12.3 [245-247 AND 249-251 NORMANBY ROAD, SOUTH MELBOURNE](#)

LOCATION/ADDRESS: 245-247 AND 249-251 NORMANBY ROAD, SOUTH MELBOURNE

1.1 To provide a Council position on Ministerial Application 13/2015/MIN/B for 245-251 Normanby Road, South Melbourne to amend the existing permit under Section 72 of the *Planning and Environment Act 1987* to provide an additional level of car parking within the podium, reconfigure the apartment layouts to include dual-key apartment layouts, change the façade and schedule of materials and provide car parking in excess of the car parking rates of the Parking Overlay.

Image 1: Approved Elevation to Normanby Road (left) v’s Proposed Elevation to Normanby Road (right). Please refer to pages 40 and 41 of **Appendix C:** Proposed Amended Plans for photomontages.

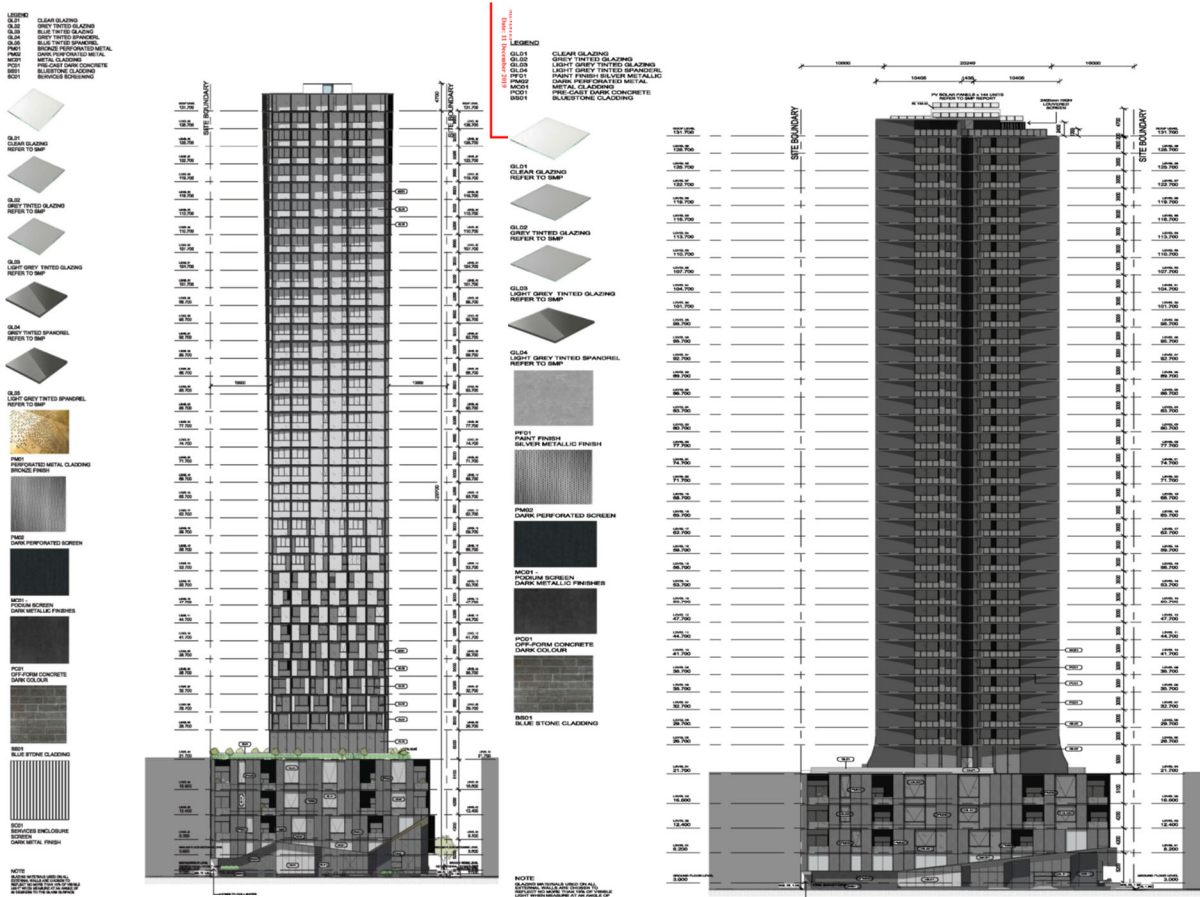
11.24 The architectural expression of the building is proposed to be amended to reflect the updated floorplates discussed above and as detailed at **Image 1**.

11.27 The amended plans add a 1.6m splayed fin at all four corners of the tower which then chamfers horizontally to form a concaved / curved profile centrally to each façade, and vertically narrows to a 1.0m projecting fin up to roof top level.

- 11.34 The minimum 1.0m wide fins of the amended plans are consistent from Level 5 to roof top level and in elevation express as a 2.0m widening of each elevation and thus increase the level of non-compliance with the requirements of DDO30.

Image 2: Proposed Rev J Amended Plans – Levels 5-39 (dated 13 March 2020) and Façade Articulation

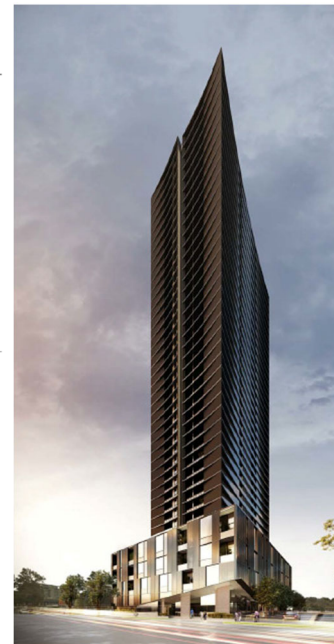
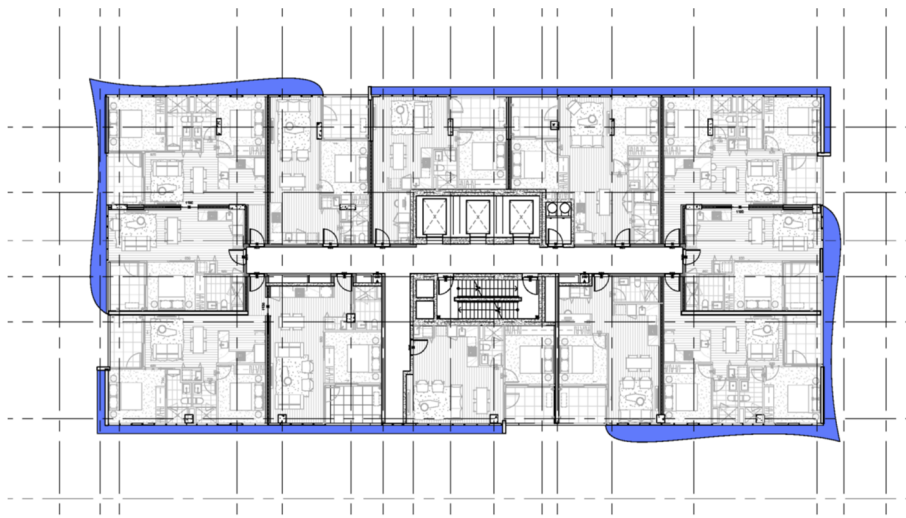
- 11.37 The proposed without prejudice amended plans seeks to delete the splayed fins to the four corners of the tower which extend into the 10.0m minimum setback requirements of DDO30 (See Image 2).
- 11.38 The without prejudice plans incorporate curved slab edges to diagonally opposite corners to Normandy Road and Woodgate Street. The slab edges extend beyond the walls. The two remaining corners are squared-off with the slab edges providing shallow eaves off the walls (see Image 3).

11.39 The without prejudice amended plans provide improved visual interest to the tower façade. The mix of curved and angular forms to both Normanby Road and Woodgate Street elevations are separated by a return to a balcony edge that assists in breaking up the massing of the façade to present a more slender built form. The same treatment to the side elevations of the proposed tower provides a similar effect to oblique views to the side elevations, creating depth, visual interest and reducing the horizontal emphasis which the original report raised concerns about.

“The amendments to the slab extrusions will provide a subtle improvement to the presentation and reading of the building. They should form an increased vertical emphasis around the recessed balconies, particularly on the west and east elevations, and creating a more fragmented reading to these facades which is supported. We assume SJB’s advice that DELWP have expressed support for the changes is correct.

Image 4: DDO 30 setback encroachments.

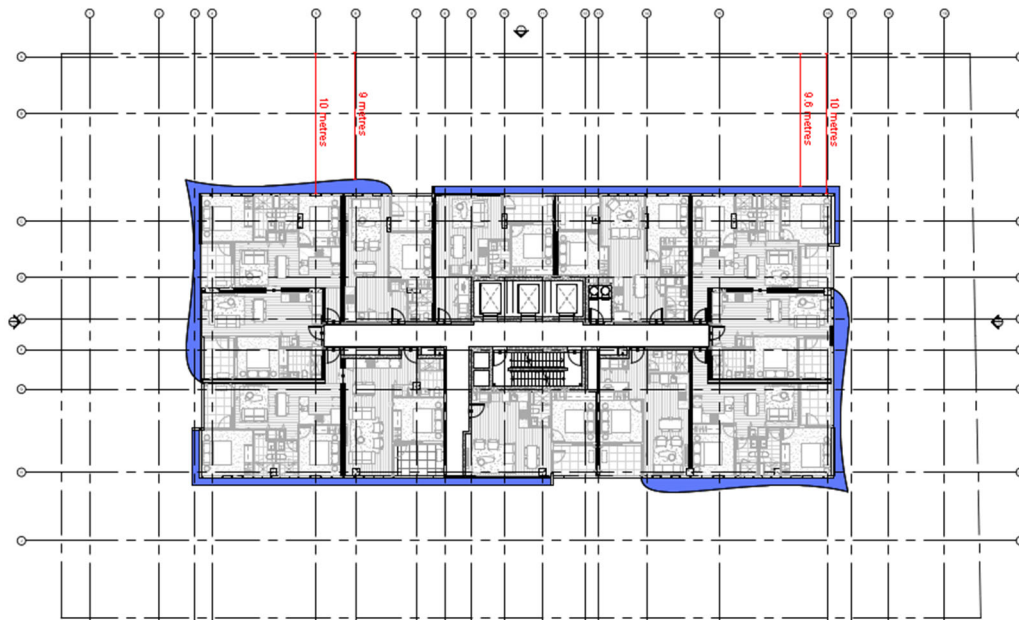
- 11.42 The without prejudice amended plans received by Council on 8 April 2020 do not include dimensioned setbacks to assist with an accurate assessment. As detailed at Image 4 of this report, the maximum encroachment into the 10.0m setback appears to range between 0.4m and 1m. Whilst still not-complaint with the current DDO 30 controls, the encroachment extends no further than current endorsed plans and therefore considered acceptable.
